# TECHNICAL INFORMATION

- Subject** ▶ Addition of Dust Seal Washer Complete and Change of Knob Complete, Gear Housing Complete, Skirt Complete and Holder
- For Models** ▶ BO6040
- Country** ▶ All countries
- Description** ▶ Knob Complete, Gear Housing Complete, Skirt Complete and Holder have been changed so that forcible rotation/ free rotation mode can be shifted smoothly. Dust Seal Washer Complete has been added.

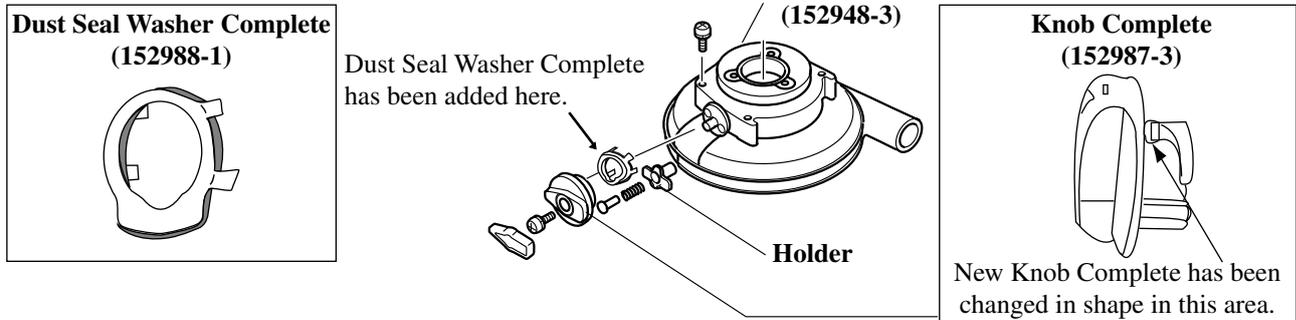
▶ Current	▶ New
<p><b>Gear Housing Complete (152671-0)</b></p> <p>Space</p> <p><b>Skirt Complete (152948-3)</b></p>	<p><b>Gear Housing Complete (152671-0)</b></p> <p>No space</p> <p><b>Skirt Complete (152948-3)</b></p> <p>No space between Gear Housing Complete and Skirt Complete in this area</p>
<p><b>Holder (162219-0)</b></p> <p>Resin</p> <p>Iron sleeve</p>	<p><b>Holder (345209-0)</b></p> <p>All iron</p>
